# 66106A-07A

## S E R V I C E N O T E

### 66106A DC Power Supply

**The instrument will not communicate or will not complete self test.**

Figure 1

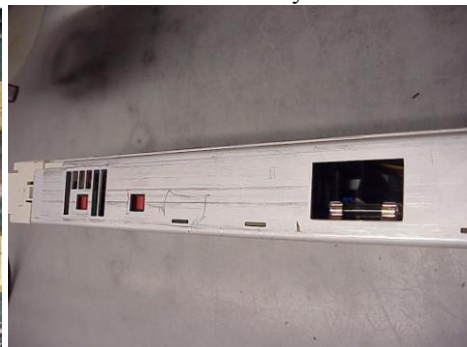
The Programmed ROM P/N 5080-2529 (Circuit Reference “U2”) See Figure 1.below for the location of “U2”. The Programmed ROM Shows “U2” can be inspected with out taking the entire instrument apart see figure 2 below. Inspect the ROM “U2” as described in Diagrams “A & B” below.

The ROM “U2” should be removed from the socket. (See Figure 1). The socket and the ROM should be inspected for contamination or other defects. The ROM is a ceramic part and can be damaged or broken if too much force is applied when reinstalled. Diagram “B” shows the ROM “U2” inserted correctly.

**FIGURE 1** Is the Tested PCA P/N 66101-61022 note (Location of Circuit Reference “U2”)

**Diagram A:** ROM not fully inserted

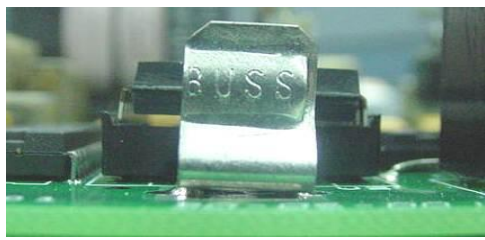
When the ROM “U2” is not inserted correctly See Diagram “A” for details, the instrument may exhibit the following faults:

These faults could also occur if the ROM or the socket is intermittent due to dirty or contaminated pins.

1. The instrument will not turn on
2. All of the segments on the Front Panel display are not light.
3. The instrument will fail self test or will not boot-up.
4. The instrument will not communicate & can not be calibrated.
